SUBJECT: PLANS AND PROPOSAL ADDENDUMS
PROJECT: STP 2023 (675)MM CONTROL: 1433-02-044
COUNTY: COMAL
LETTING: 05/04/2023
REFERENCE NO: 0419

PROPOSAL ADDENDUMS

DESCRIPTION OF ABOVE CHANGES
(INCLUDING PLANS SHEET CHANGES)

NOTE:
 SEE GEOMETRIC DATA SHEETS FOR HORIZONTAL ALIGNMENT INFORMATION.
 SEE MISCELLANEOUS CURB AND SIDEWALK DETAILS FOR SIDEWALK AND CURB DETAILS.
 SEE DRIVEWAY DETAILS AND SUMMARY SHEETS FOR DRIVEWAY DETAILS AND QUANTITIES.
 SEE RETAINING WALL LAYOUTS FOR RETAINING WALL DETAILS.

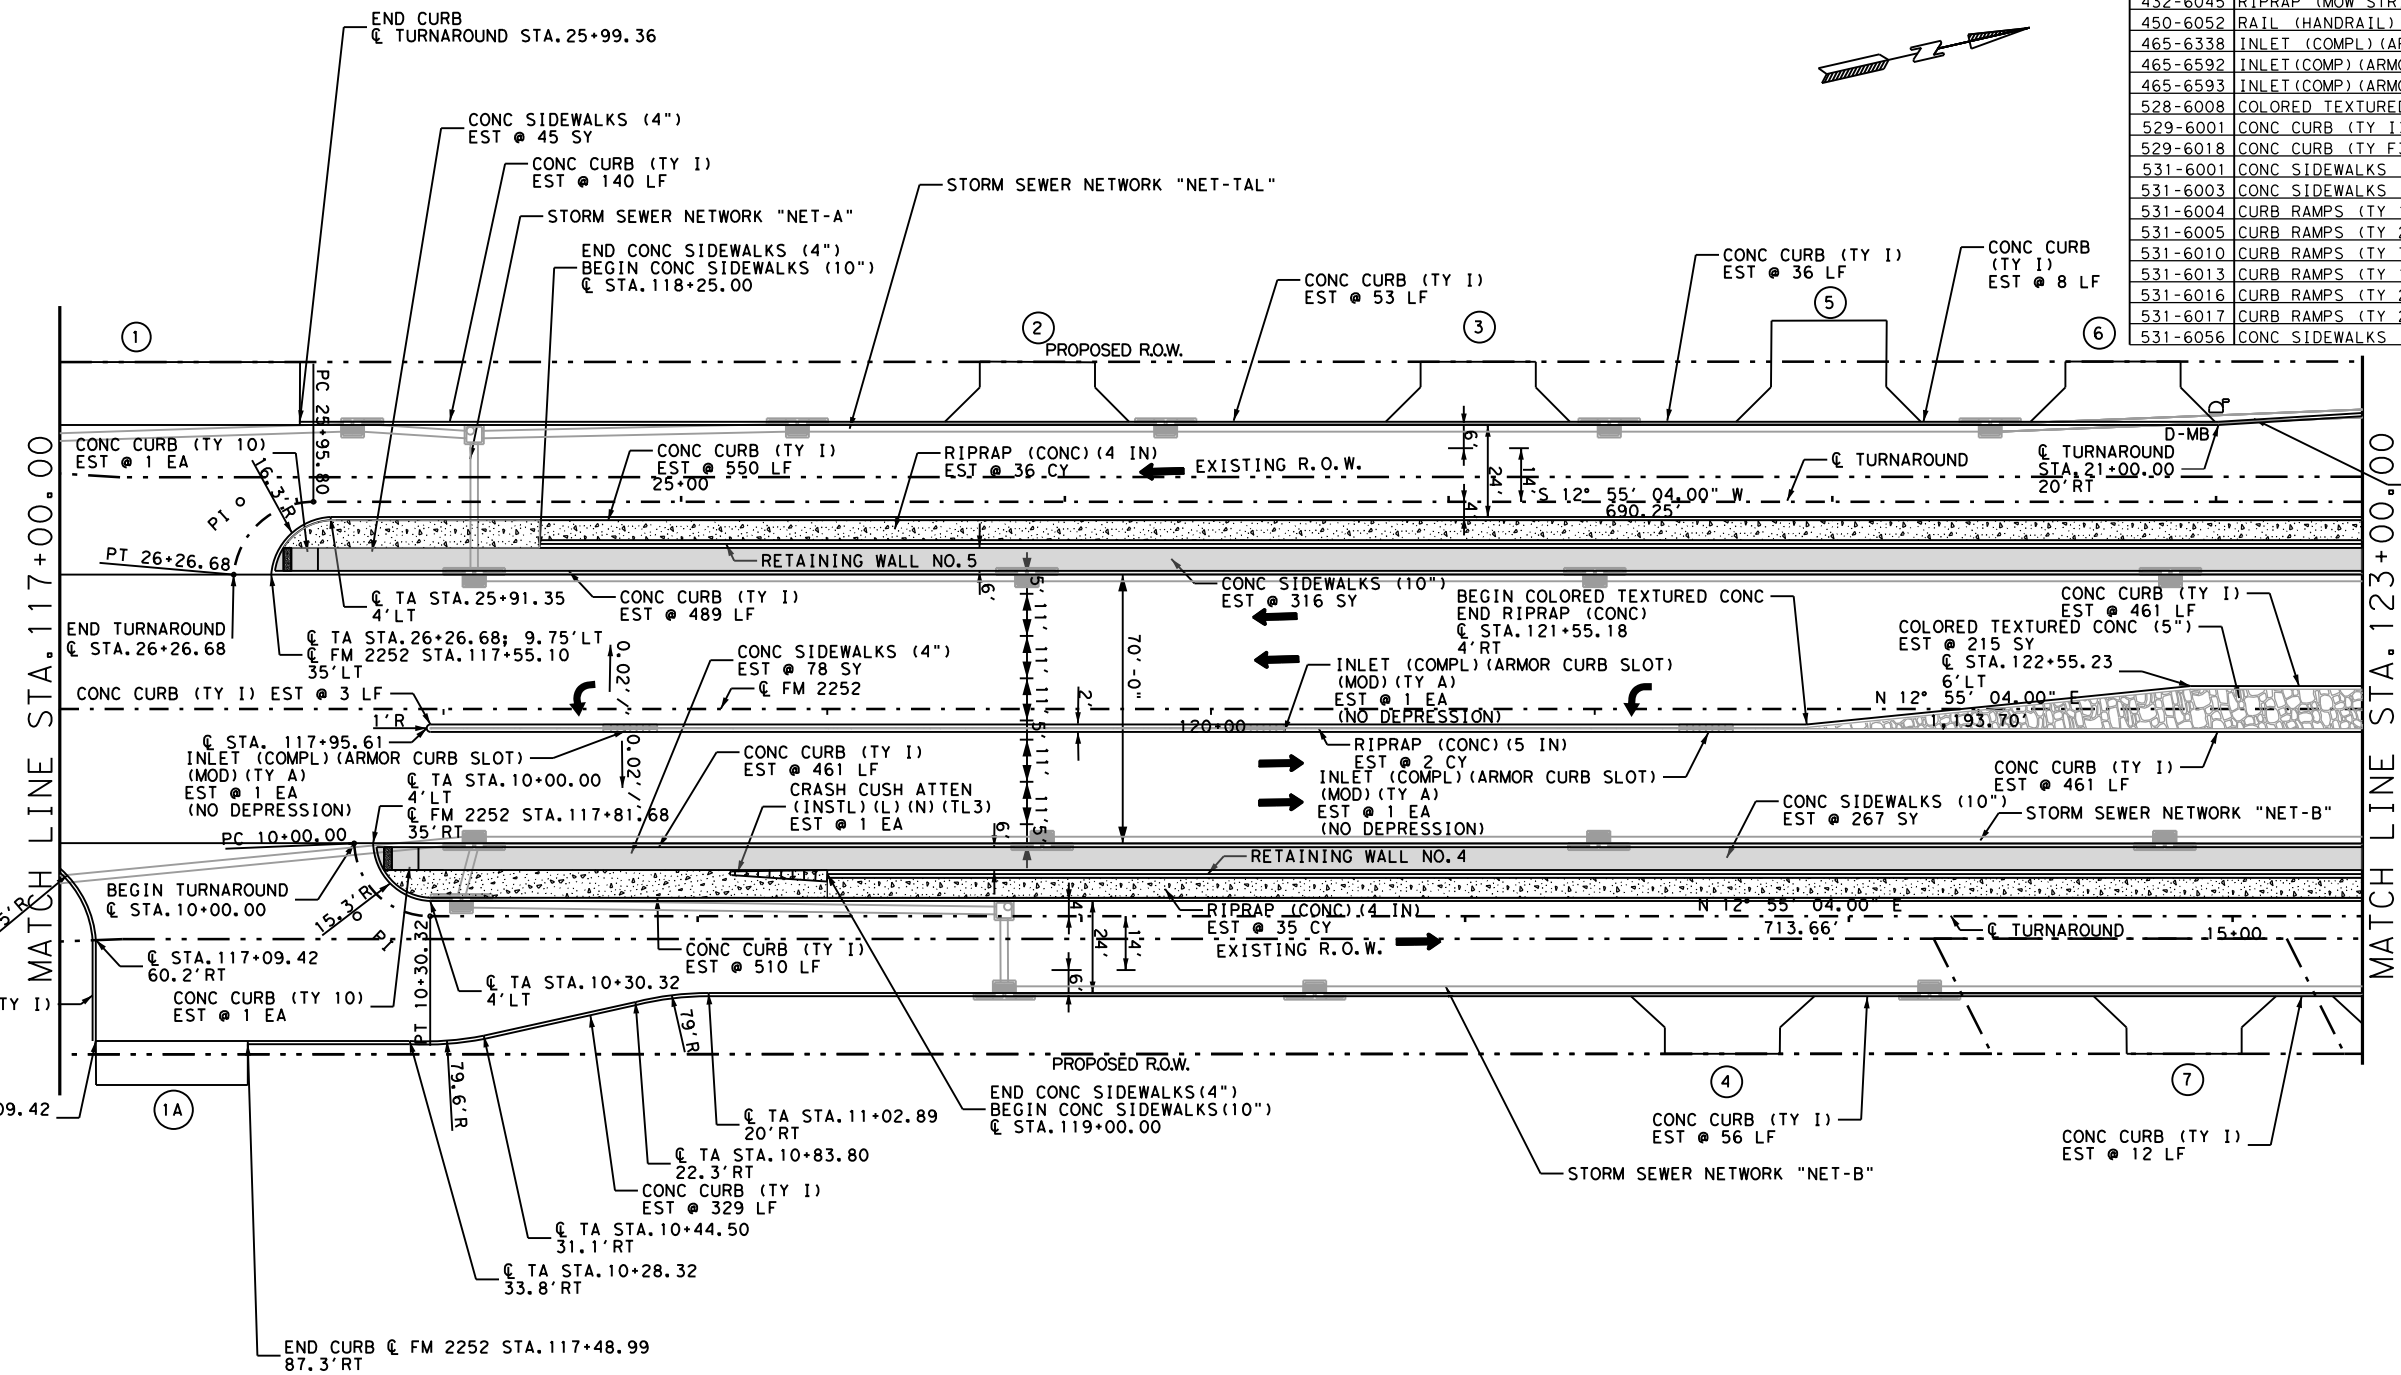
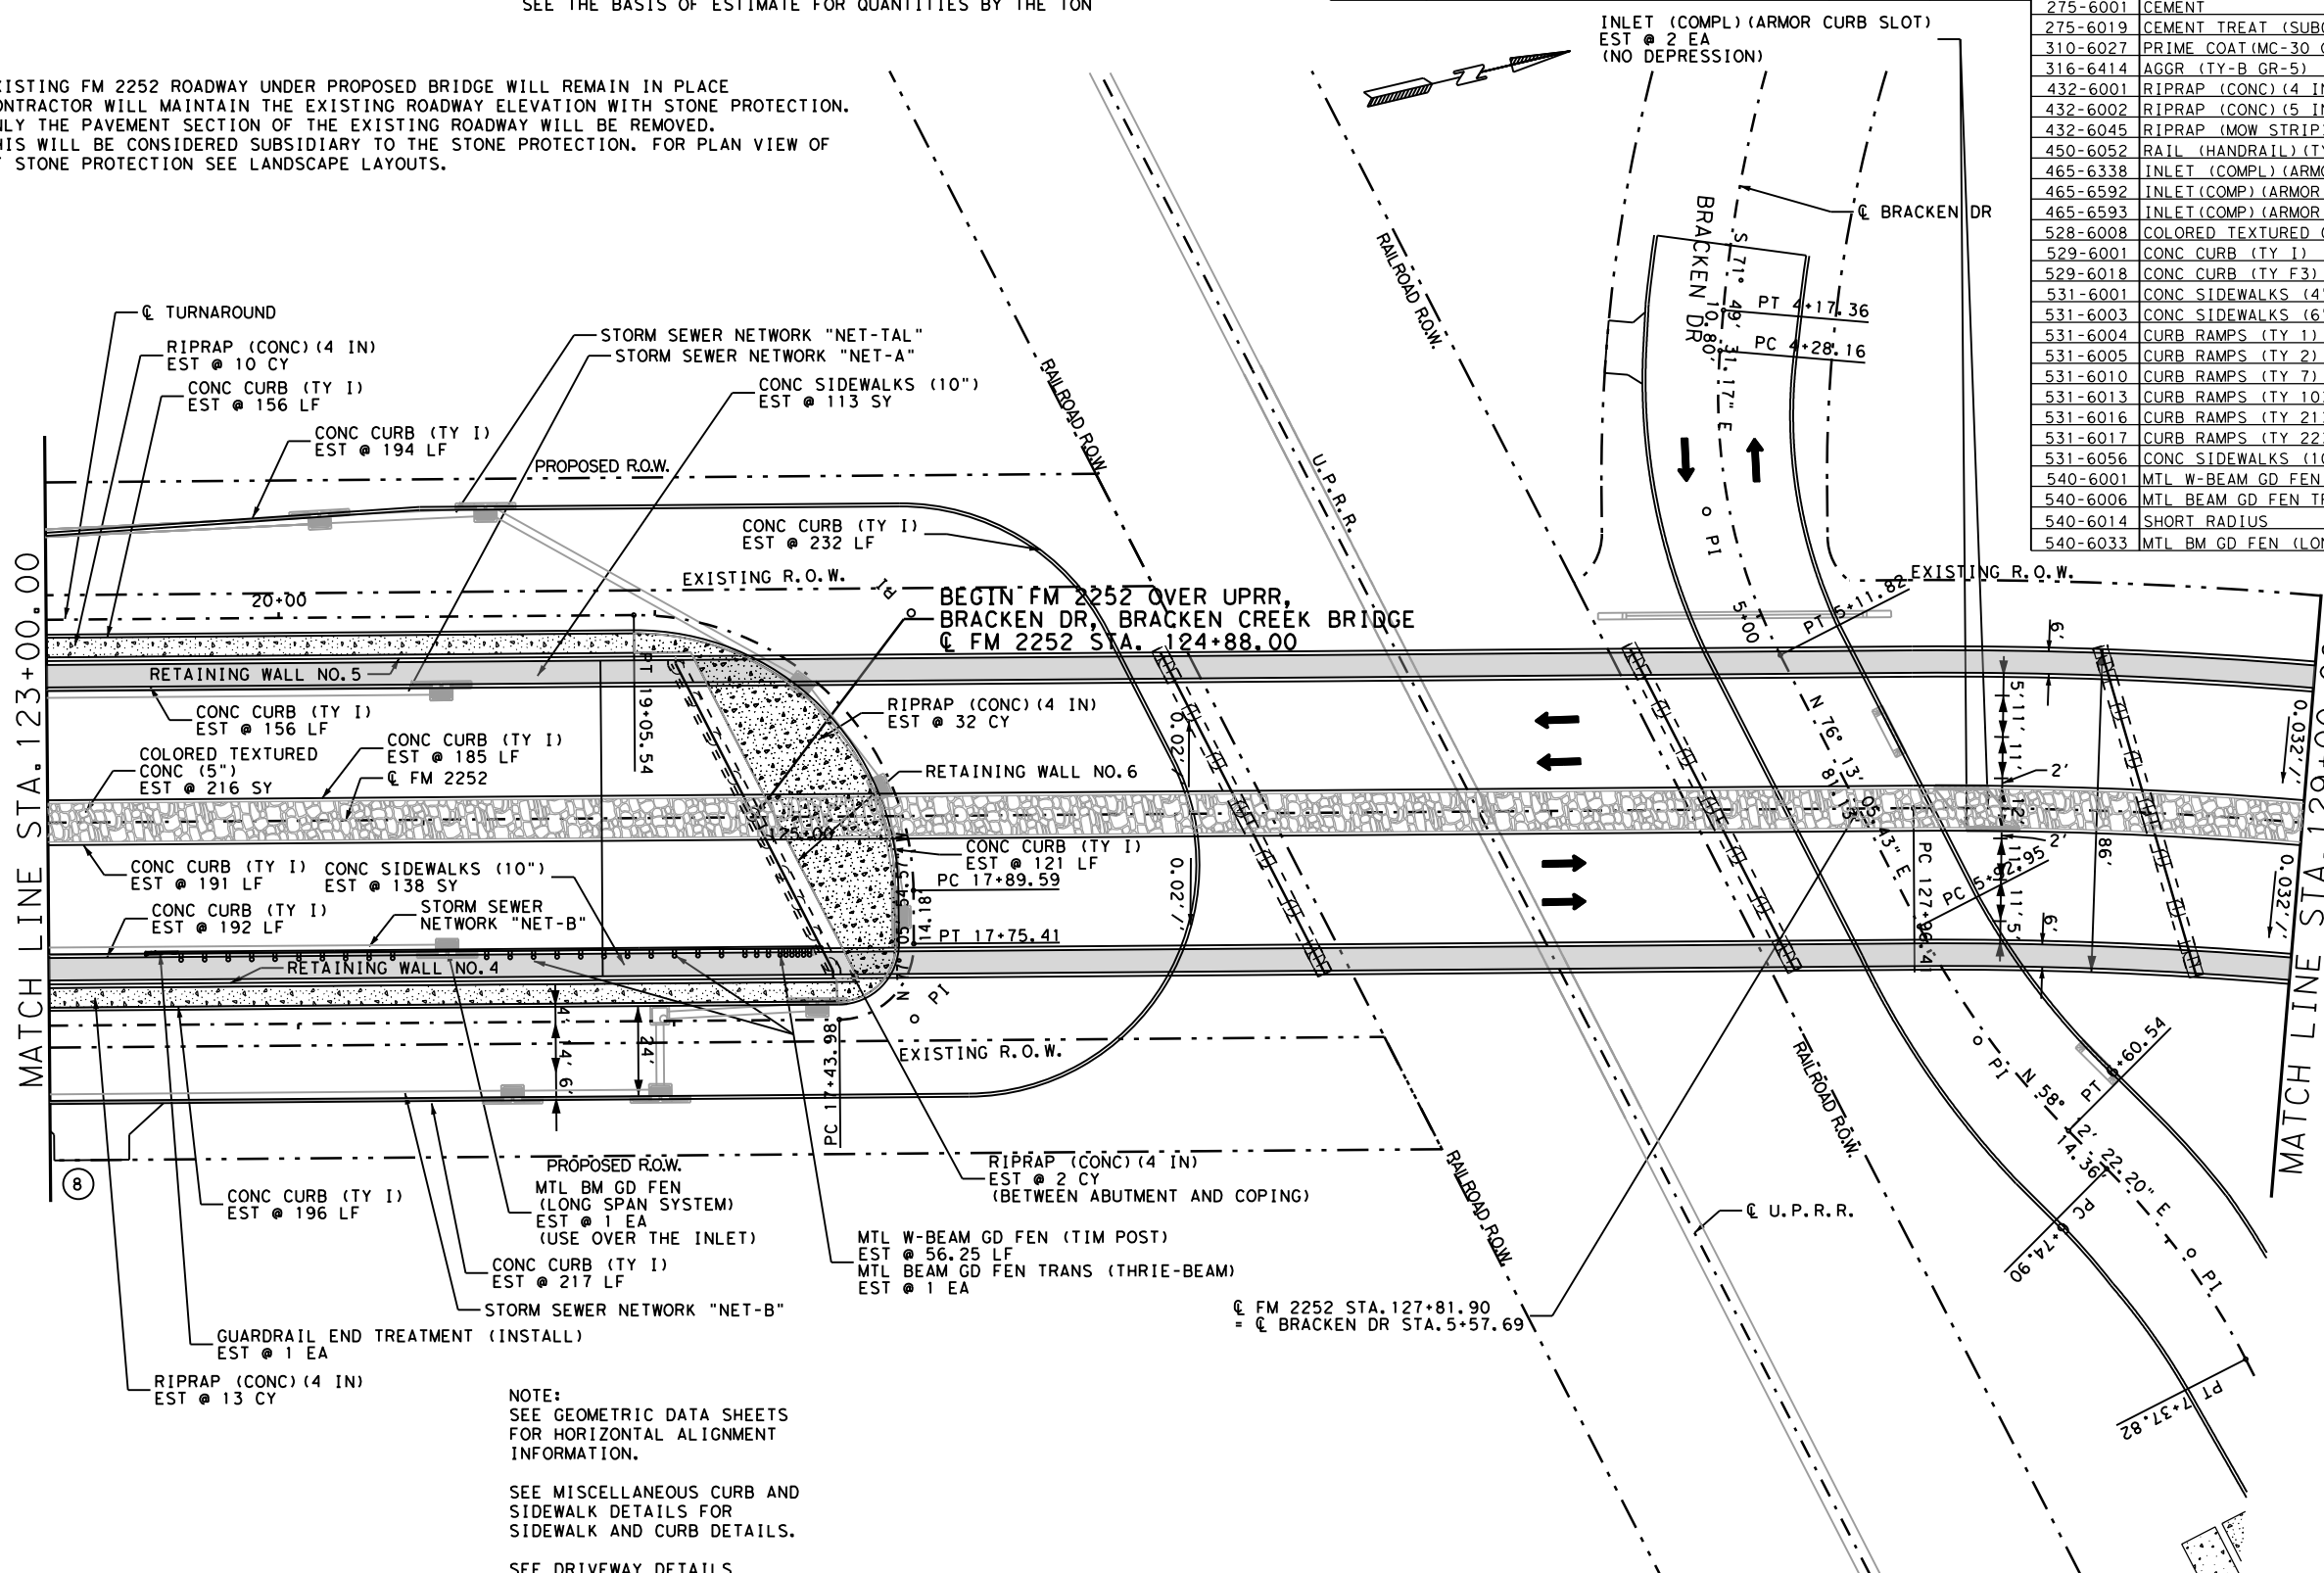
SHEETS 413-449: REPLACED ITEM NO. 545-6017 WITH ITEM NO. 545-6007
